# CITY OF ALBUQUERQUE

**Re: Duranes Elementary School Kindergarten Addition, 2436 Zickert Rd. NW,  
(H-12/D006)**

**Approval of Permanent Certificate of Occupancy,**

**Re: Duranes ES Kindergarten Add'n Grading Plan Certification**  
**2436 Zickert Rd NW**  
**Engineer's Stamp dated 9-19-08 (H12/D6)**

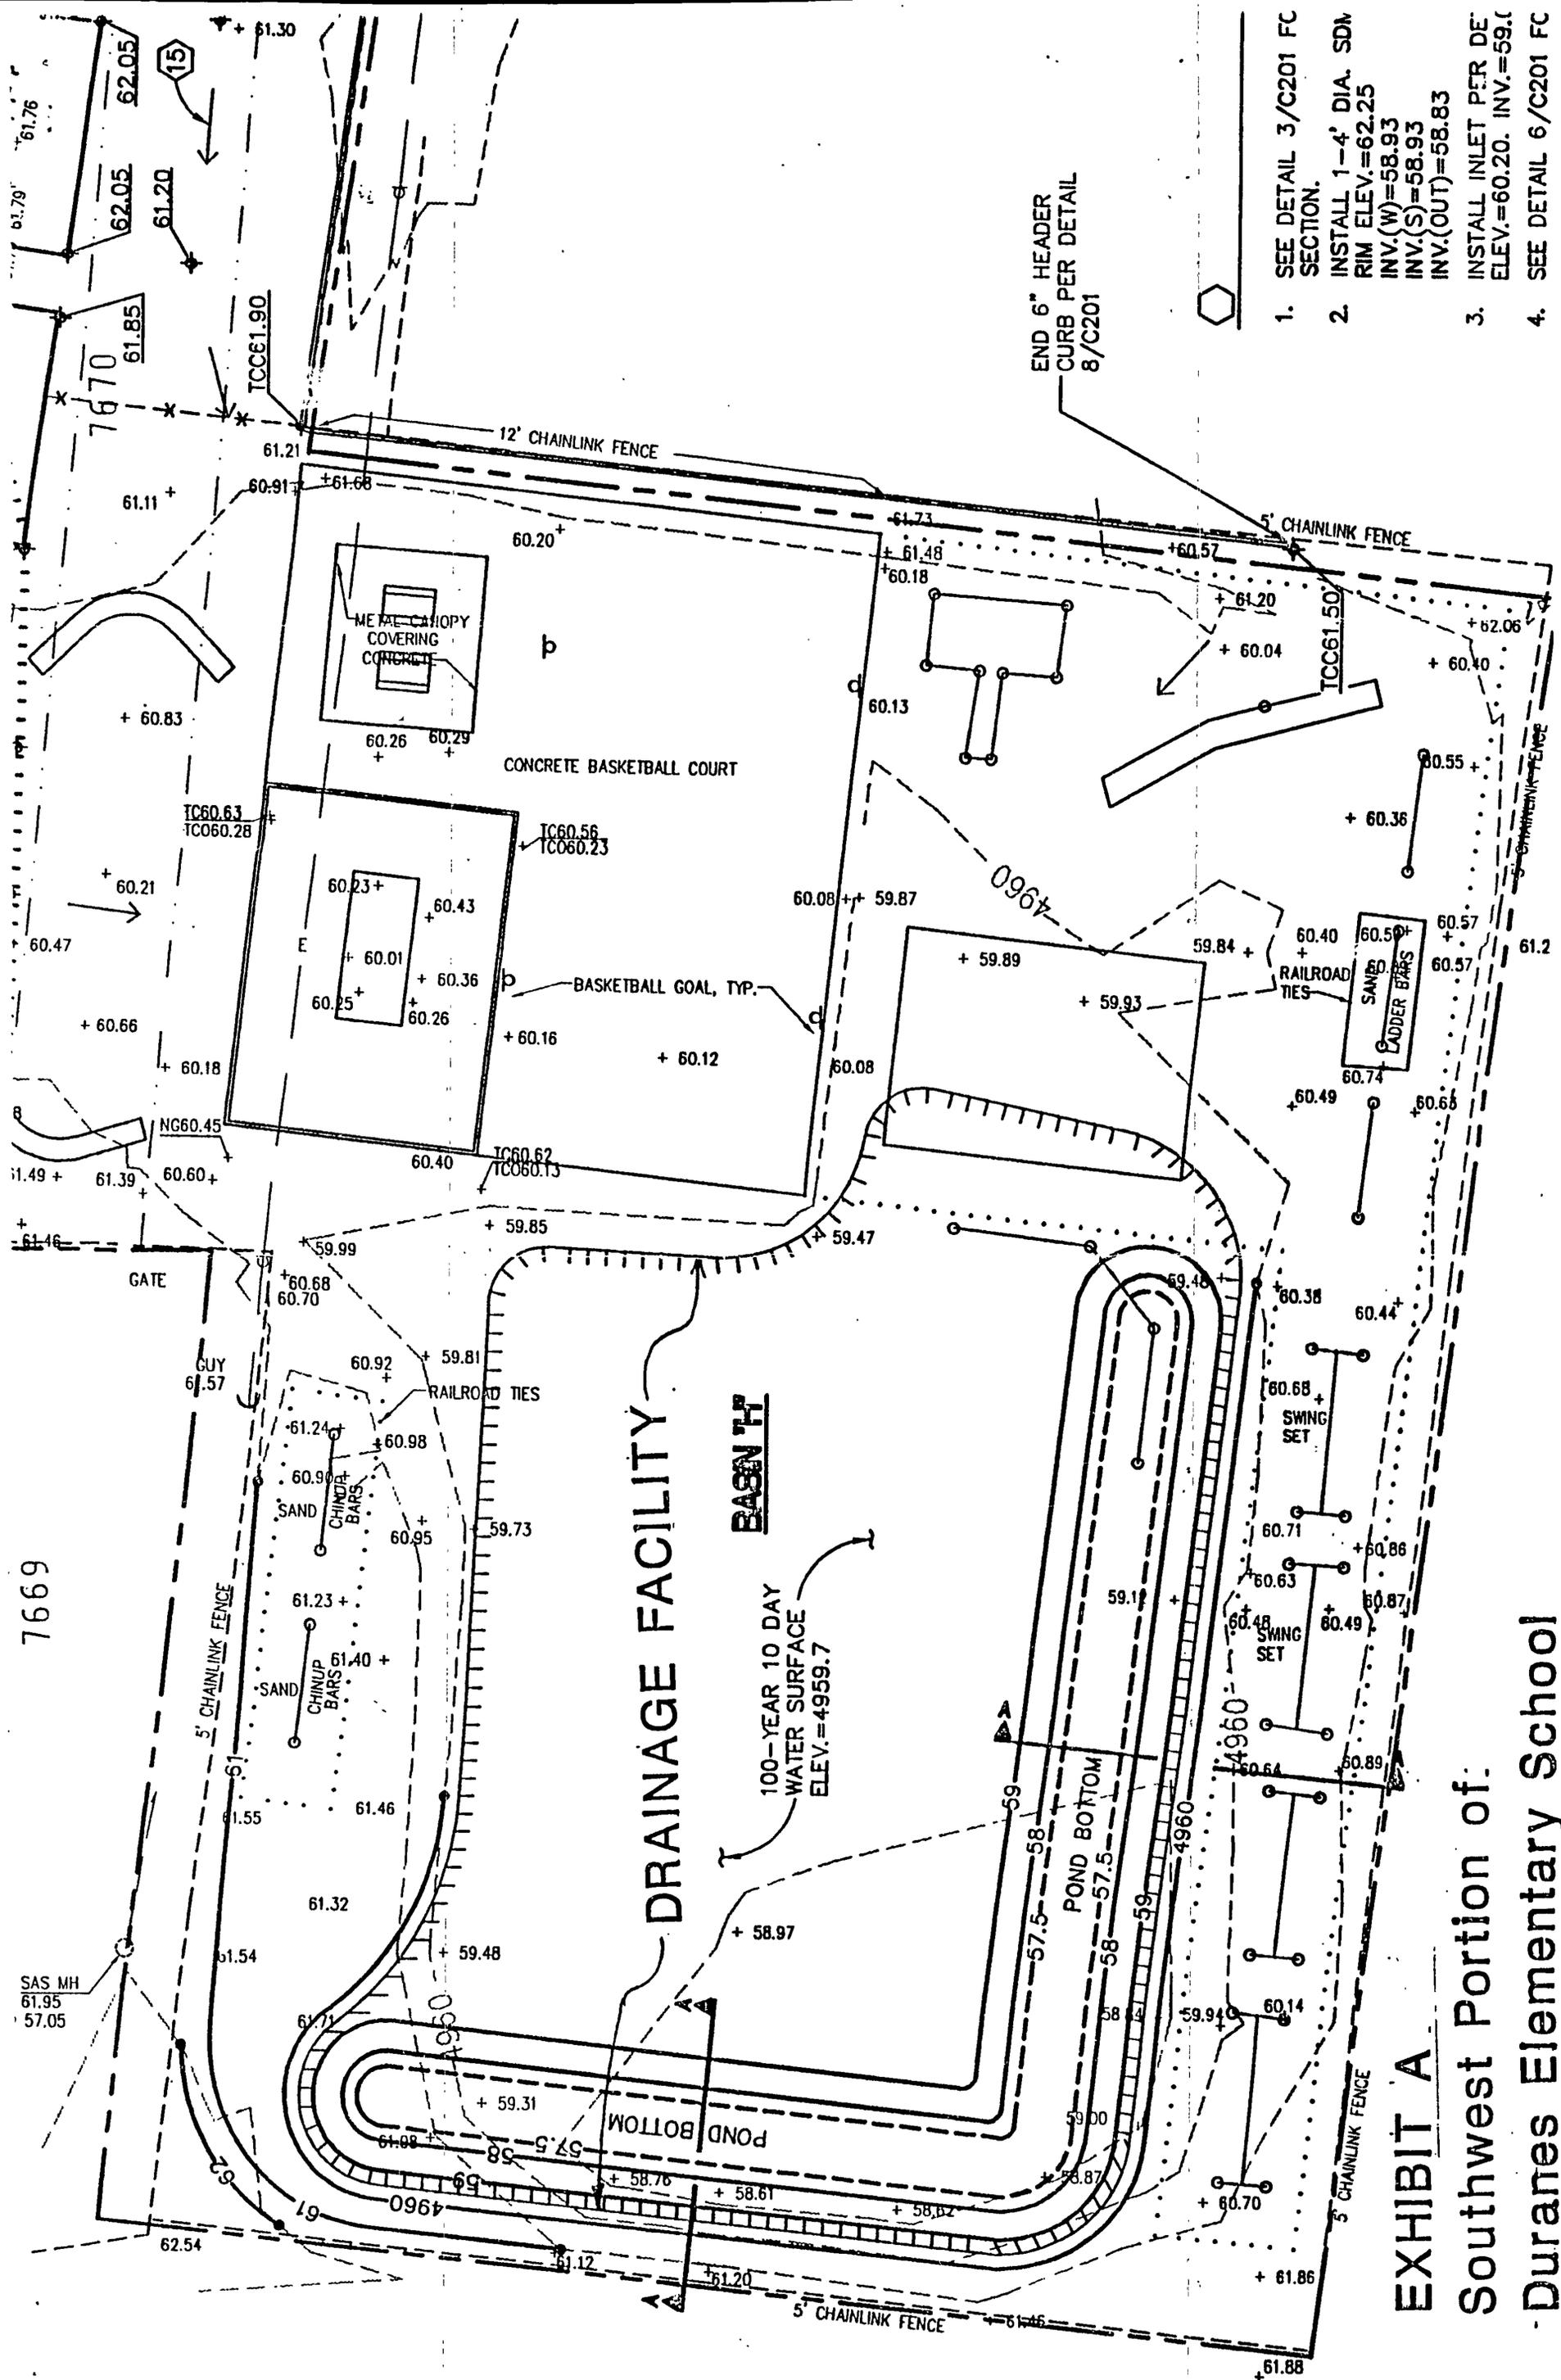
1. SEE DETAIL 3/C201 FC SECTION.
2. INSTALL 1-4' DIA. SDM RIM ELEV.=62.25 INV.(W)=58.93 INV.(S)=58.93 INV.(OUT)=58.83
3. INSTALL INLET PER DETAIL 6/C201 FC ELEV.=60.20. INV.=59.0
4. SEE DETAIL 6/C201 FC

END 6" HEADER CURB PER DETAIL 8/C201
